City of Surrey
PLANNING & DEVELOPMENT REPORT

File: 7912-0086-00

Planning Report Date: July 23, 2012

for an industrial/business park building with second-storey banquet hall.

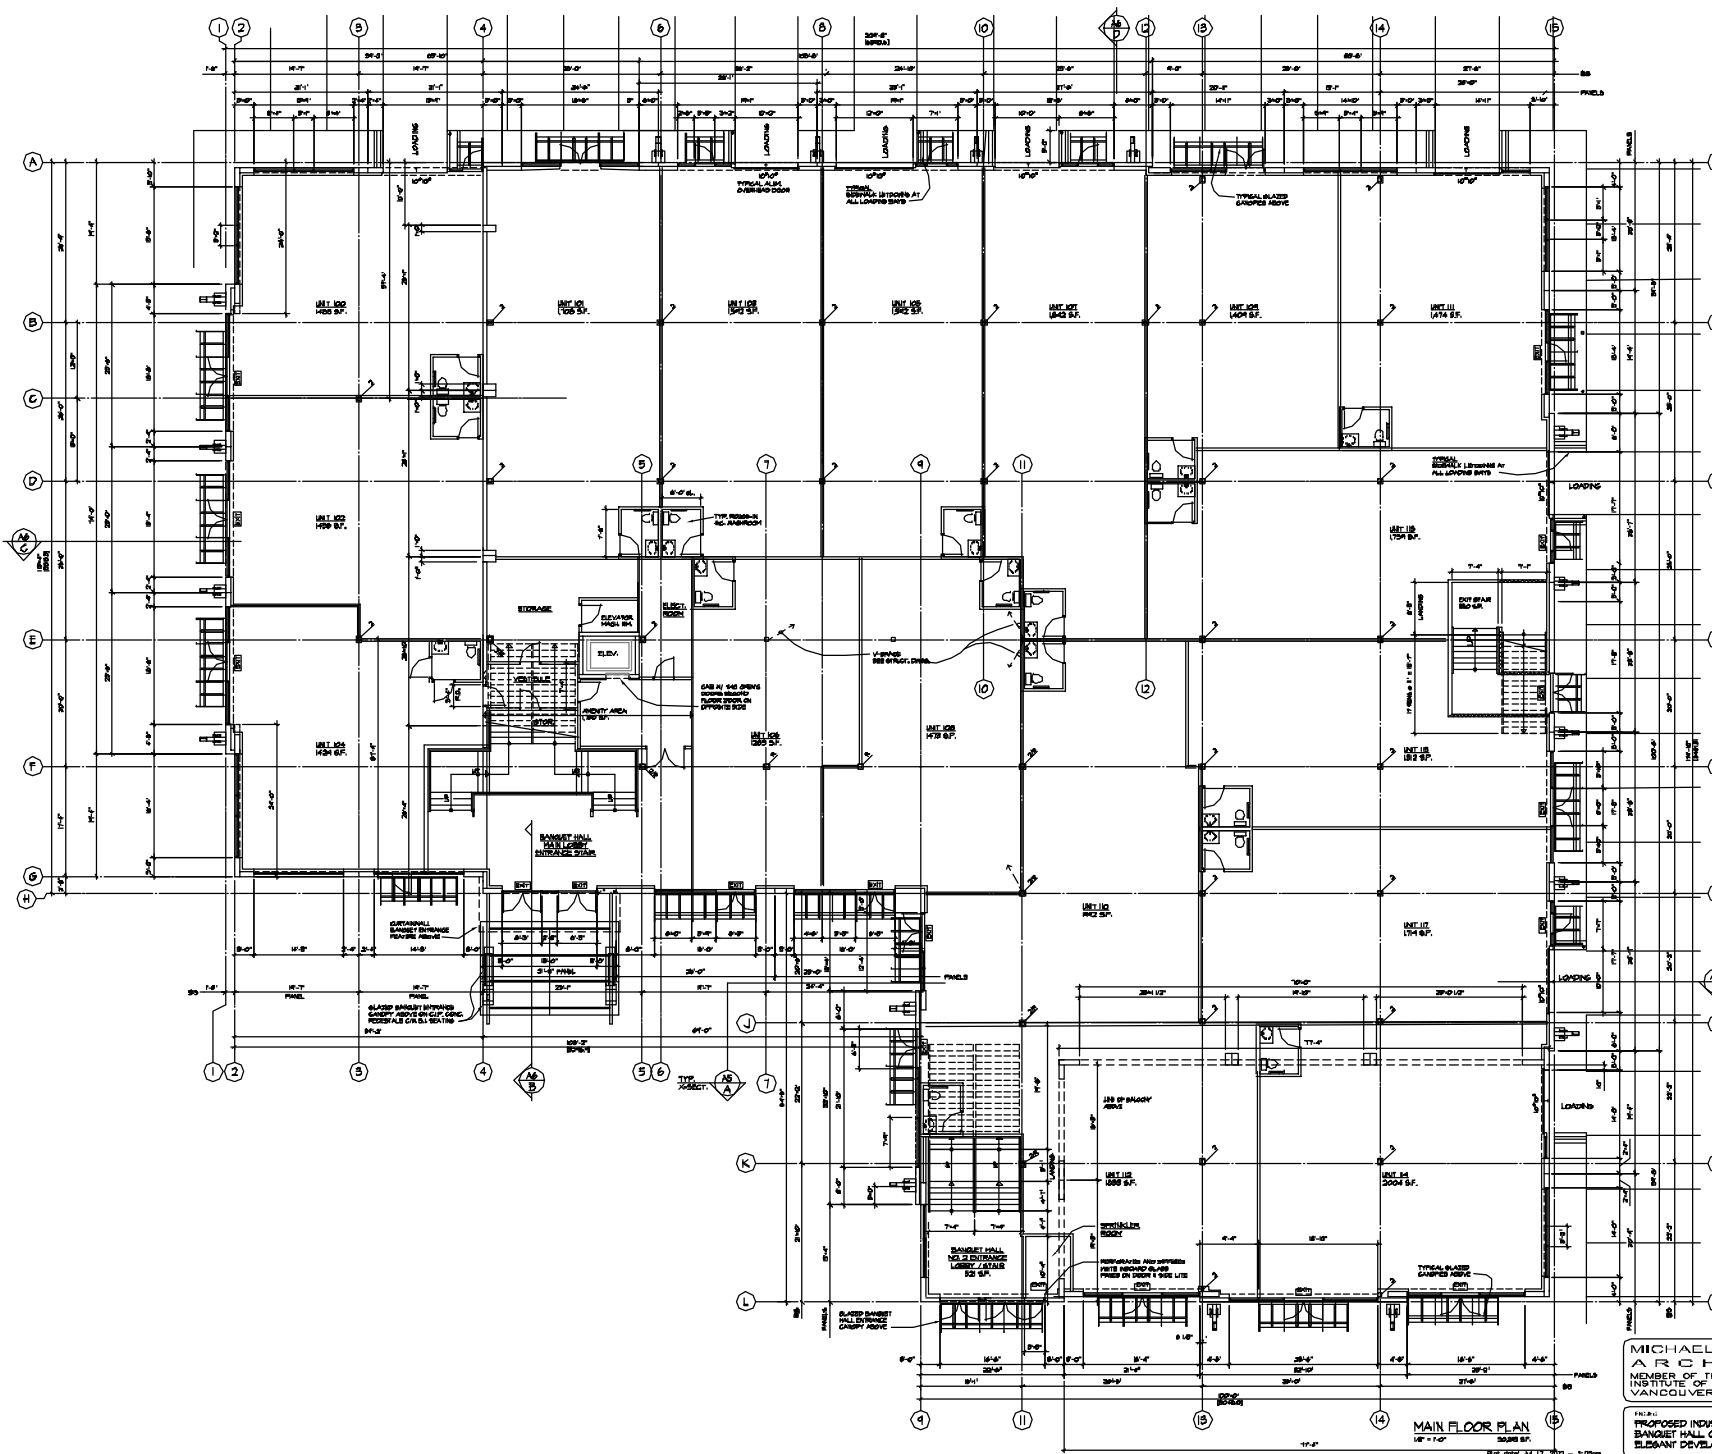
- The applicant's written response to previous ADP comments is disrespectful of the panel's assessment of the building orientation.
- The applicant was provided with a possible solution to the building orientation and building program requirements. However, the applicant has not addressed the ADP recommendations/comments.
- In general, the applicant has missed an opportunity to celebrate the banquet hall function and make the building work better with existing site constraints.

- Provide better pedestrian connectivity from sidewalk to courtyard entrance.
- Provide better pedestrian circulation through the proposed parking lot.
- The differentiated pavement located outside the courtyard entrance does not improve pedestrian circulation or illustrate the location of the principal entrance.

- Remove any impediments the additional landscaping poses to vehicular circulation.

WEST ELEVATION

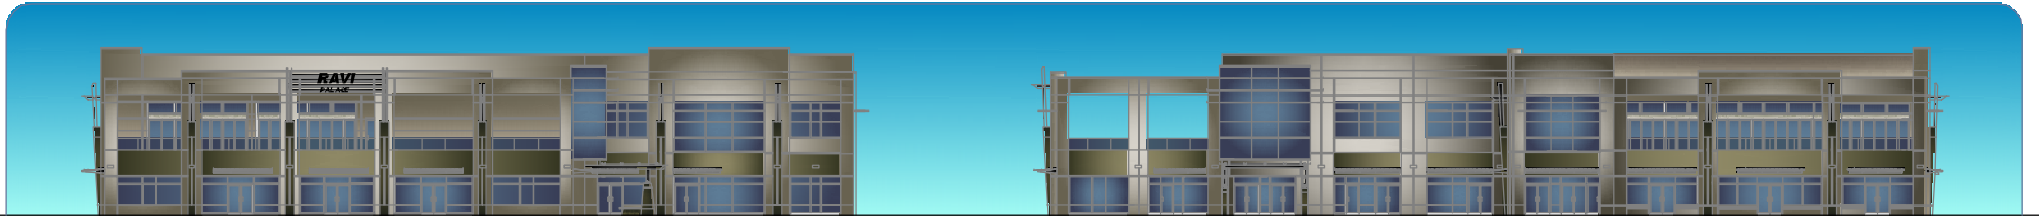
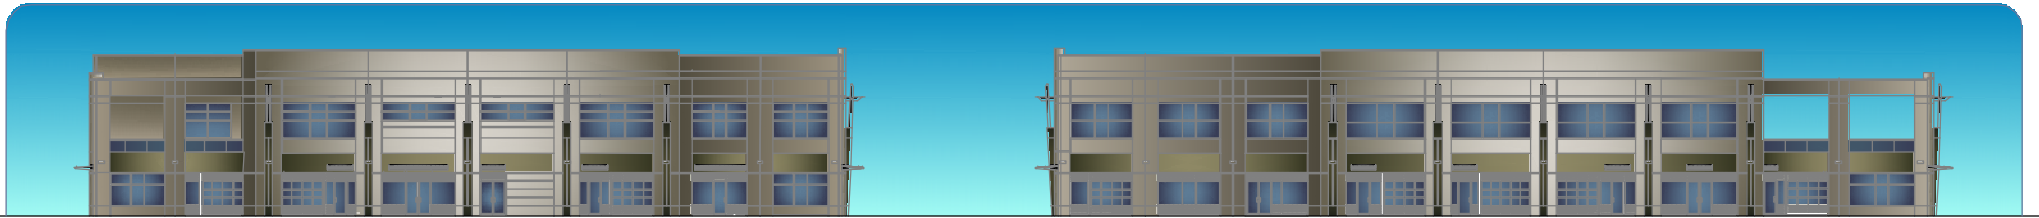
- The building is proposed to be 12.0 metres (40.0 ft) in height, which is the maximum permitted under the CD By-law.
- The second floor (banquet hall) ceiling height is proposed to be 7.1 metres (23.4 ft). According to the applicant, the tall ceiling is required to establish appropriate proportions relative to the large floor area of the banquet hall.

- With the second floor proposed to be overheight, the ground floor ceilings are proposed at 4.4 metres (14.6 ft) in order to remain within the maximum building height.

- Staff have concerns that the 4.4 metre ceilings are not conducive to industrial operations and will not attract industrial businesses to this site. The units are configured to be more attractive to commercial uses than industrial.

- Staff have consulted experts in the development of industrial business parks and determined that a ceiling height of 5.5 metre (18.0 ft) or greater is more appropriate for industrial operations.

- Industrial units typically range in height from 5.5 metres (18.0 ft) to more than 7.3 metres (24 ft). in order to be functional for industrial purposes. Accordingly, a height of at least 5.5 metres (18.0 ft) is more appropriate than the 4.4 metres (14.6 ft) proposed by the applicant. A 5.5 metre ceiling would allow for increased storage and warehousing capacity within the ground-floor units, and is more comparable to industrial buildings elsewhere in the City.

1. Council refer the application back to staff, to work with the applicant to increase the ground floor ceiling height from 4.4 metres (14.6 ft) to 5.5 metres (18.0 ft).
